AMENDMENT NO. 2 FEBRUARY 2022

IS 15275 : 2003 PADLOCKS — SPECIFICATION

FIG. 7 CIRCULAR CLOSED SHACKLE PADLOCK

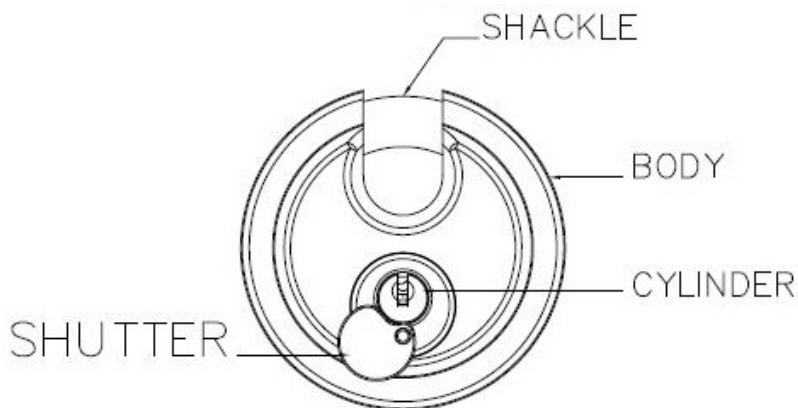
[Page 8, clause 5, first sentence, (see also Amendment No 1)] — Substitute the following for the existing :

‘The typical shape and design of padlocks and their parts indicated in Figs. 1, 2, 3, 4, 5, 6, 7 and 8 are intended to be illustrative and for guidance only.’
